Planning Application 2026/91657 – Fourth externally expressed level, discrepancies in the lowest-level construction and Green Belt impact

I wish to raise a further objection concerning the lowest level of Plot 23 and the resulting height, scale, massing and external appearance of the dwelling.

Four externally expressed levels

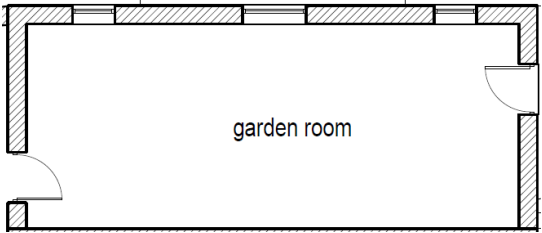
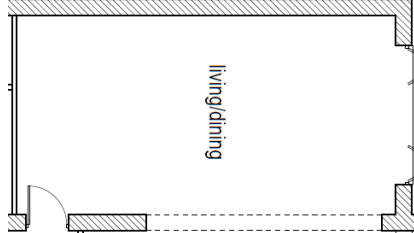
The submitted rear elevation presents four clearly distinguishable horizontal levels:

1. the lowest garden-room and store level;
2. the lower-floor level opening onto the raised patio;
3. the floor above containing a further row of windows; and
4. the upper level expressed within the substantial roof form.

That does not, however, remove its contribution to the external height, scale, bulk and massing of the building. It contains substantial enclosed floorspace, full-height external entrances and several windows. In my view, when seen from the rear or downhill side, it forms the lowest of four externally distinguishable levels and causes the elevation to appear as a four-storey built form.

Plot 23  garden room	Plot 34  living/dining
Area of floor = 41.34 m²	Area of floor = 34.87 m²

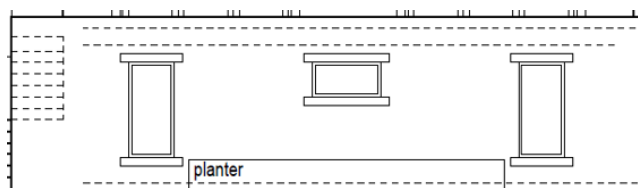
The scale of the garden room shown in the current application is particularly striking when compared with the immediately adjacent Plot 34. My more detailed measurements from the submitted plans give the Plot 23 garden room an area of approximately **41.34 square metres**, compared with approximately **34.87 square metres** for Plot 34's principal living/dining room.

The additional garden room at Plot 23 is therefore approximately **6.47 square metres, or 18.6%, larger** than the principal communal living space of the adjoining dwelling.

This is not a marginal comparison. A single room introduced at Plot 23's additional lowest level is substantially larger than the main living/dining room of the neighbouring house. Its scale makes it difficult to characterise as a minor use of residual underbuild or an insignificant ancillary space. It represents a substantial addition to the usable floorspace, built volume and intensity of development at Plot 23.

The combination of its floor area, dedicated access, windows and architectural treatment indicates that it is intended to provide substantial usable domestic or ancillary accommodation. Its floorspace and built volume should therefore be included fully when assessing:

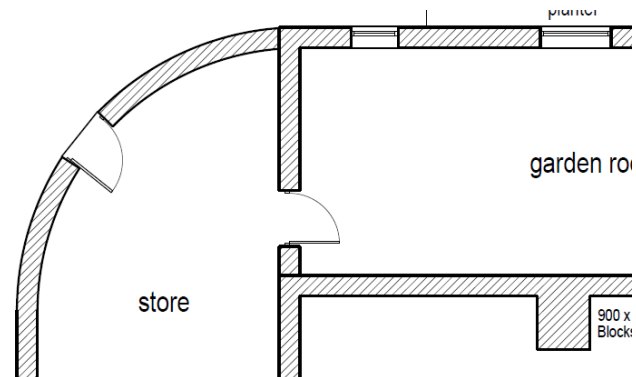
The submitted rear elevation shows two tall outer windows and a much shallower central window, with the central sill beginning several masonry courses above the sills of the windows on either side.

A photograph taken while the garden-room inner leaf was being formed appears to show the lower parts of all three window openings beginning at the same datum: *see right, with a yellow line identifying the bottom of apparent openings*. If the central window were genuinely intended to begin several courses higher, it would ordinarily be expected that blockwork would have been constructed beneath it up to the intended sill level. It remains possible that the lower part of the central opening will subsequently be infilled. However, that possibility is not evident from the construction photographed and reinforces the need to confirm the final opening dimensions.

A later photograph shows three steel lintels positioned above the garden-room window openings. The number and general positions of the openings appear broadly capable of alignment with the floor plan. I do not presently assert that the window widths have conclusively been shown to differ, because the steel lintels extend beyond the finished openings to provide bearing.

However, the construction evidence continues to raise a significant question regarding the **height and depth of the central window**. It suggests that the central opening may ultimately be as deep as the two outer openings rather than the shallow window represented on the published elevation.

Kirklees Council should therefore obtain the as-built rough-opening dimensions and final proposed dimensions of all three garden-room windows before determining the application.

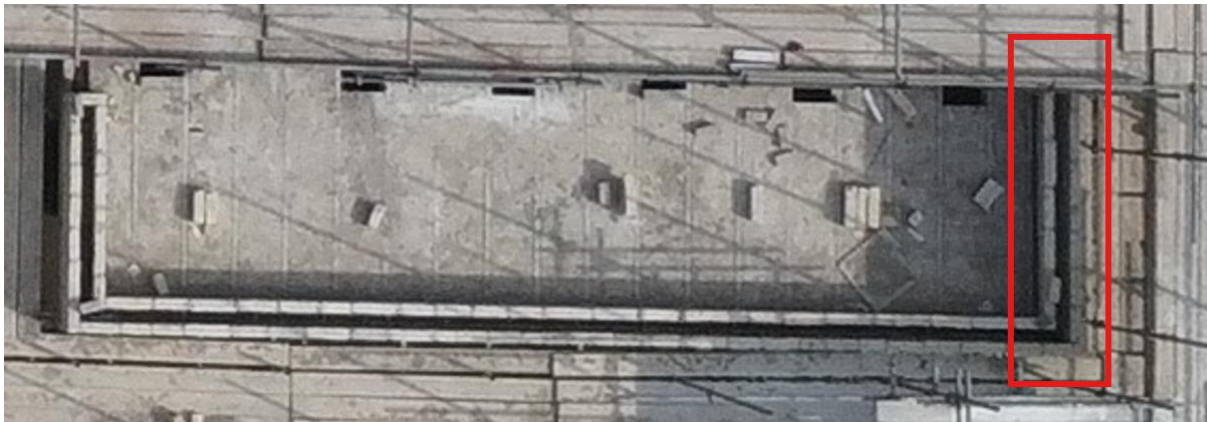
A further construction photograph raises concern about the arrangement of the raised patio above the garden-room level.

The published drawings appear to depict the raised patio as a substantially continuous terrace extending across the rear of the lower floor, with a low perimeter wall and toughened-glass balustrade along its exposed outer edge. No internal cross-wall or balustrade dividing the terrace is clearly shown.

The construction photograph, however, appears to show a permanent masonry wall or substantial upstand projecting from the lower-floor elevation into the patio area. It is positioned broadly above the point where the wall of the additional lowest level changes direction towards the kitchen.

The photograph also shows what appears to be a horizontal damp-proof course, cavity tray or waterproofing membrane emerging from the lower-floor wall at a level materially above the present block-and-beam deck. Although the final patio build-up will raise the current surface, the membrane provides an indication that the completed patio level is likely to remain below it. This makes it unlikely that the projecting masonry will simply disappear within the finished floor construction.

If the masonry remains above the completed patio surface and is surmounted by the proposed glass balustrade or another guarding system, it would create a permanent barrier across the terrace. The raised patio would consequently be divided into separate areas, and it would not be possible to move freely along the patio from its eastern side towards the dining-room side in the manner apparently suggested by the published plans.

The applicant should therefore provide:

- a dimensioned plan of the completed raised patio;
- its finished surface level;
- the purpose and level of the visible membrane;
- the position, length and final height of the projecting masonry;
- the complete proposed balustrade arrangement;
- details of any opening or route around the feature;
- a section through the patio, wall and additional level beneath;
- and an elevation showing how the completed arrangement will appear.
